Product Change Notification

Change Notification #: 113272 - 00
Change Title: Intel® Workstation System P4304CR2LFKN
PCN 113272-00, Product Design
Update the Power Cable
Date of Publication: October 3, 2014

Figure-1 GPGPU Power Cable

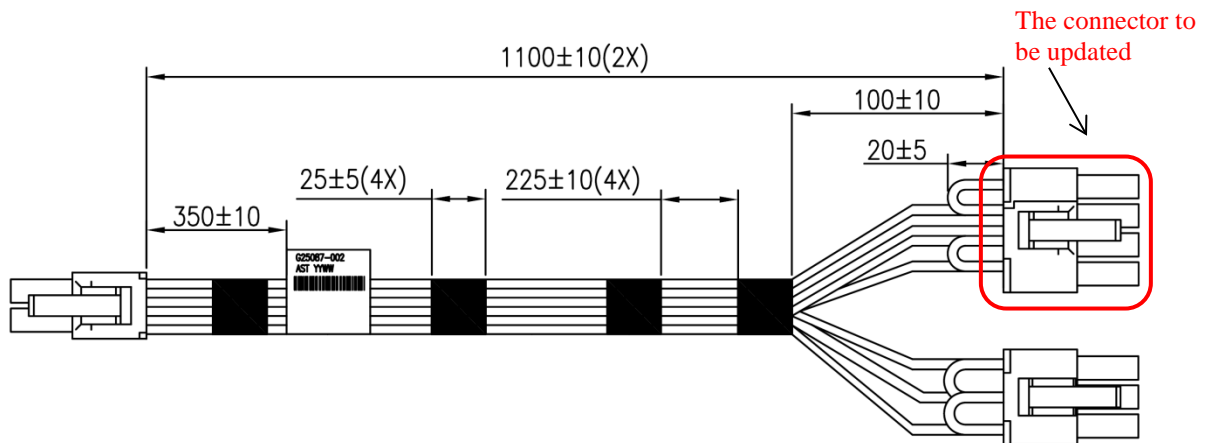
- Update the GPGPU power cable (Figure-1) by splitting the 2x4-pin connector (Figure-2) into two connectors (Figure-3): one 2x1-pin connector and one 2x3-pin connector, to improve the flexibility of integration. The Product Number is updated from G25087-001 to G25087-002.
